Map showing altitudes of water levels in artesian wells and contours on the ^{geometric} artesian-pressure surface ^{near} Palmer and vicinity.

Figure 8.

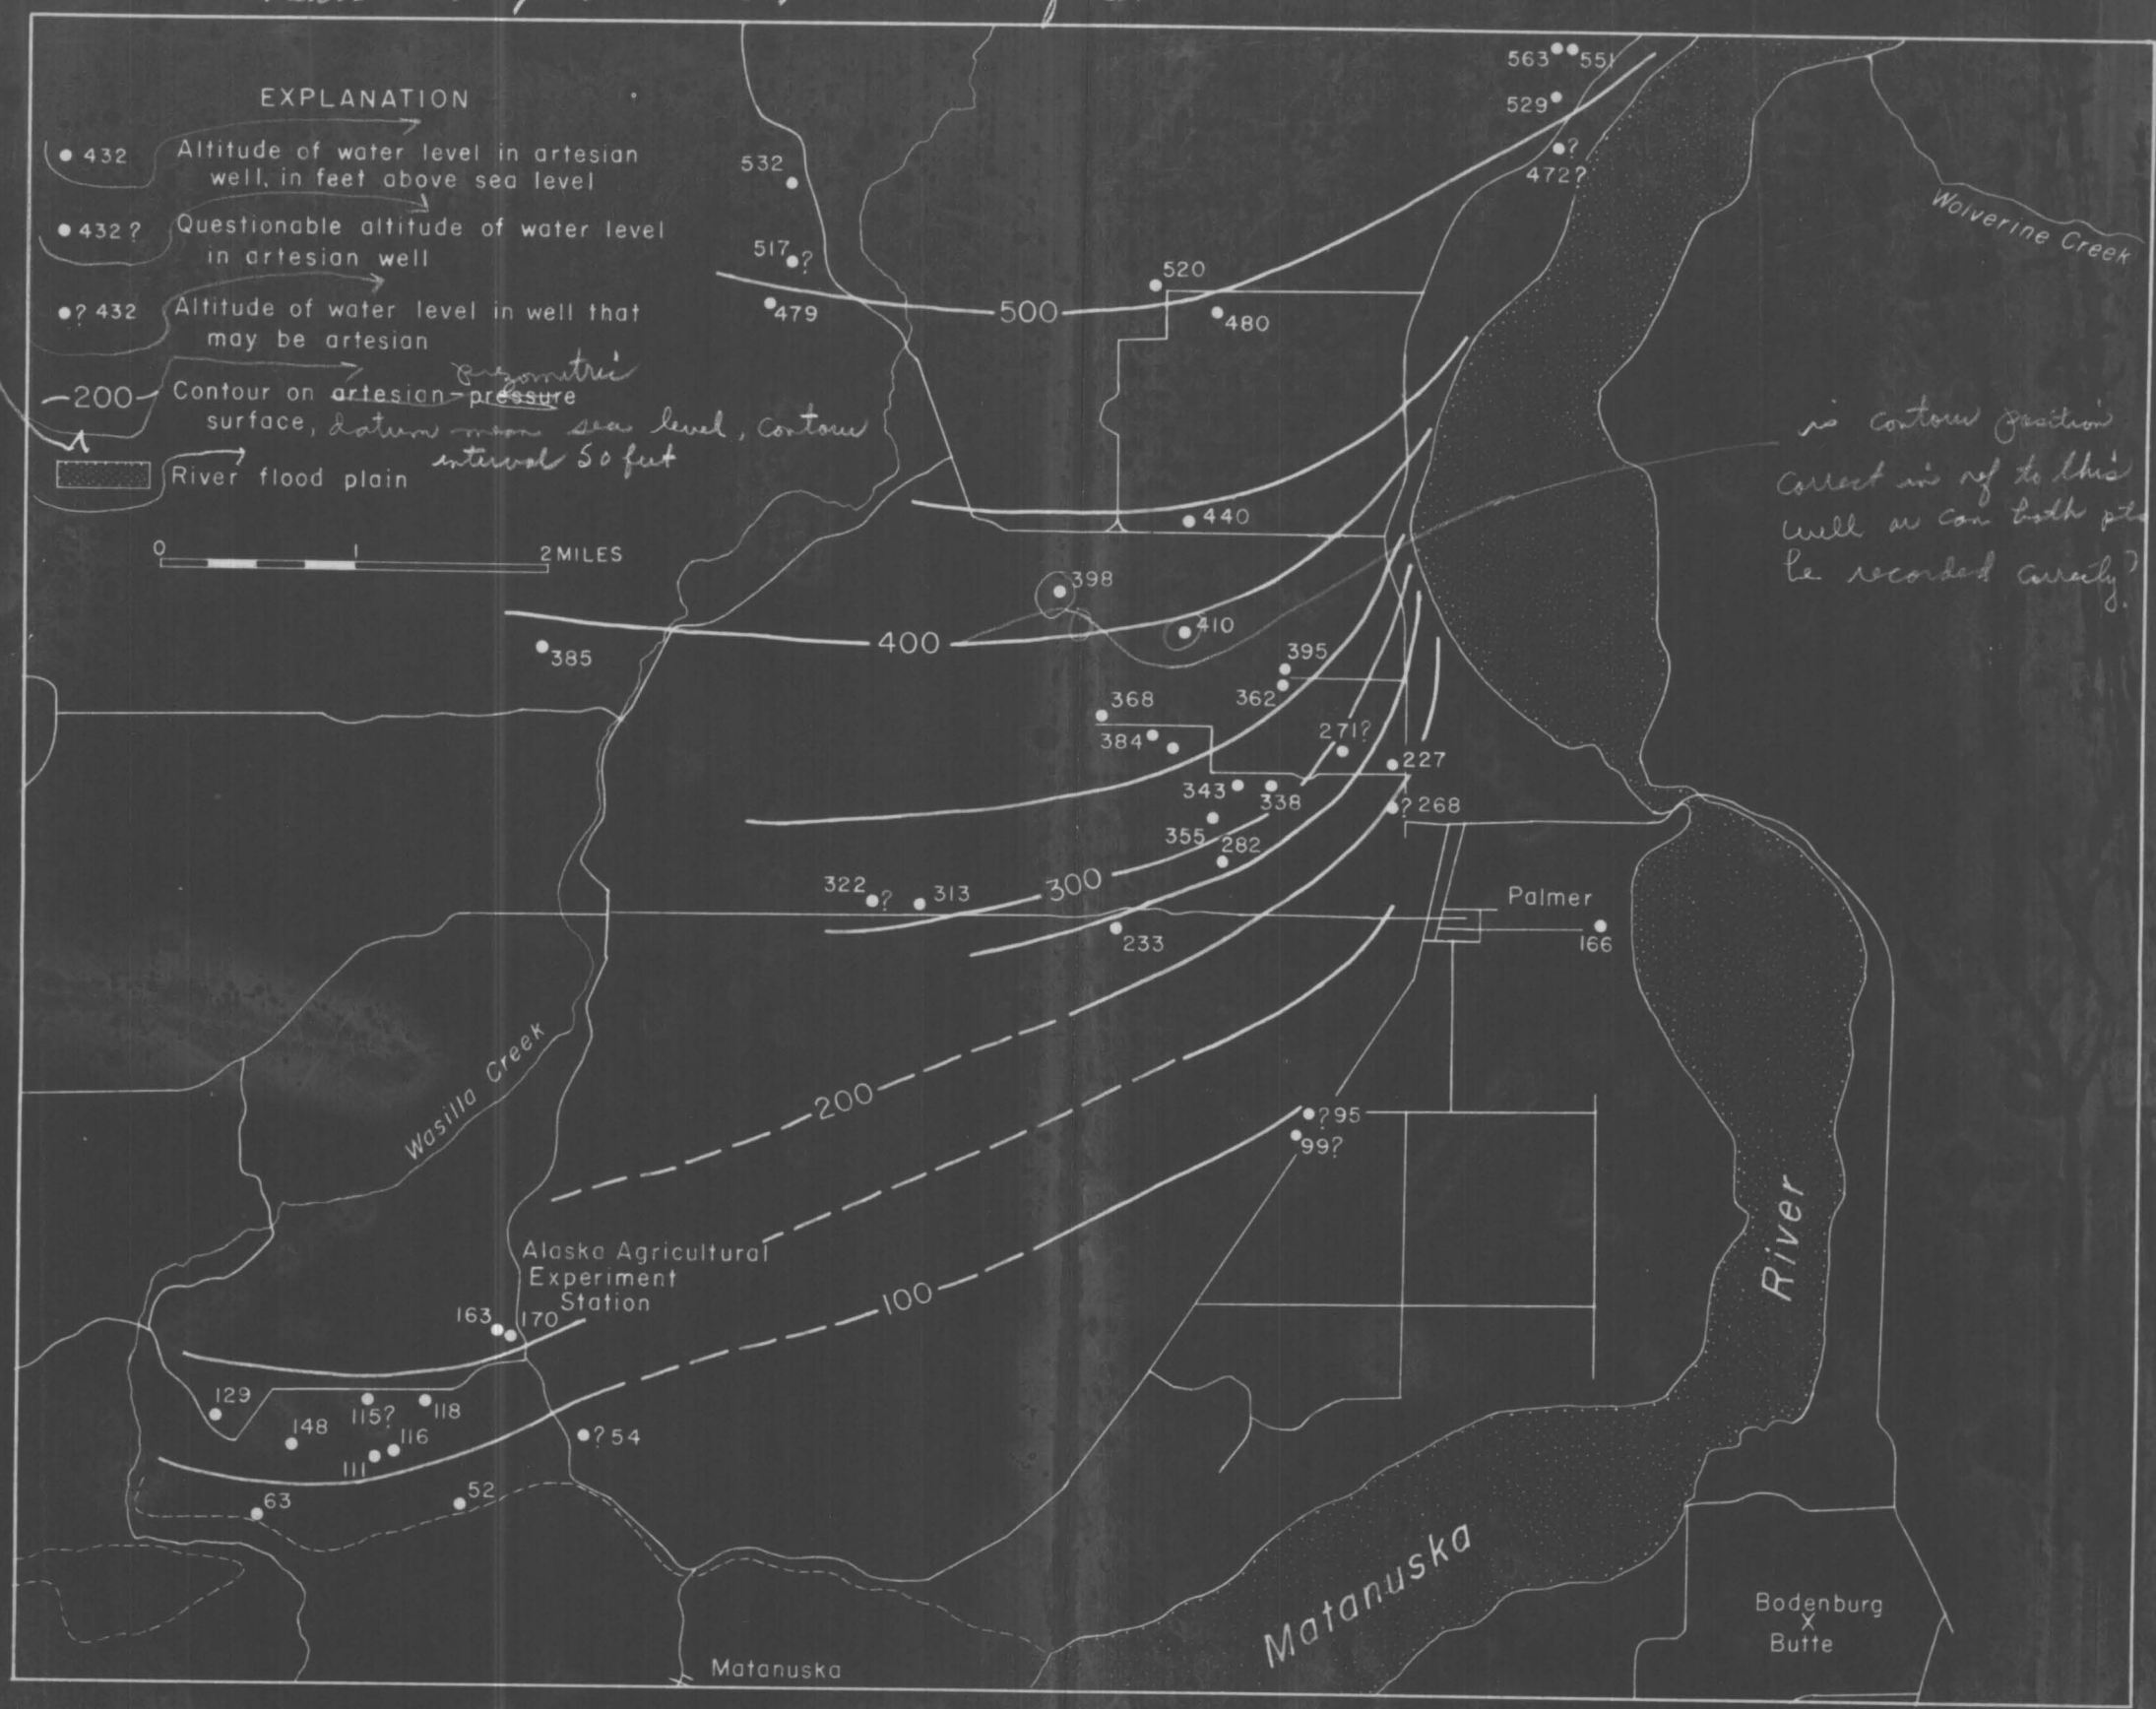
Add: See Plate 1 for numbers of wells, and Table 5 for dates of water-level measurements and depths to water from land surface. FT

is contour position correct in ref to this well as can both pts be recorded correctly?
